Mask Set Errata 2

MC9S12H256 Microcontroller Unit

- 1K78X mask of the MC9S12H256 and MC9S12H128

SPTEF FLAG SET WRONGLY**MUCTS00704**

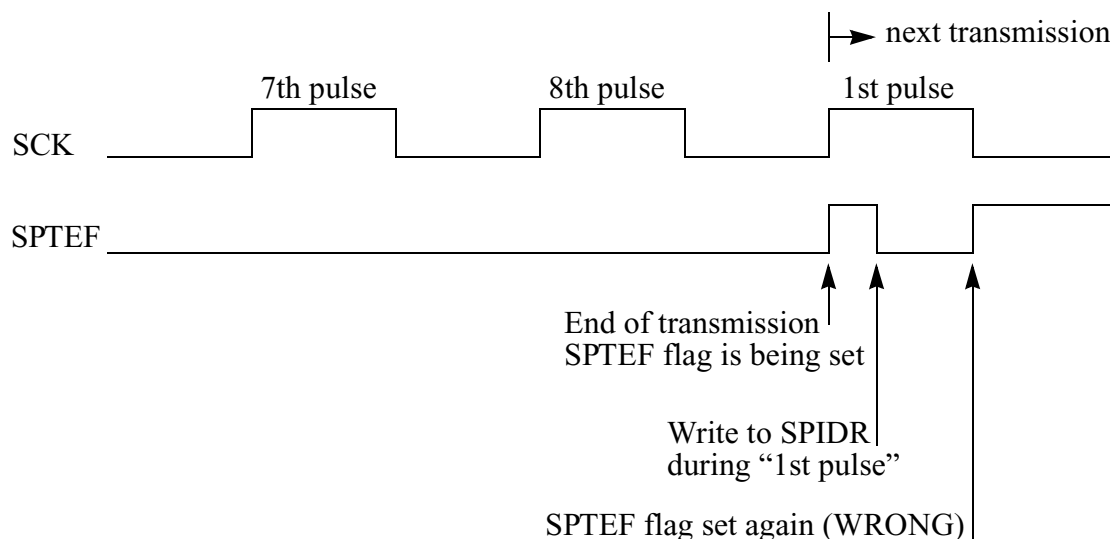
When the SPI is enabled in master mode, with the CPHA bit set, back to back transmissions are possible.

When a transmission completes and a further byte is available in the SPI Data Register, the second transmission begins directly after the “minimum trailing time”.

The problem occurs when, after the SPTEF flag has been set, a further byte is written into the SPI Data Register during the “1st pulse” of a subsequent transmission .

Then the SPTEF flag is set at the falling SCK edge of the “1st pulse” and data is transferred from the SPI Data Register to the transmit shift register. The result is that the transmission is corrupted and data is lost.

After the SPTEF flag has been set, a delay of 1/2 SCK period has to be added before storing data into the SPI Data Register.
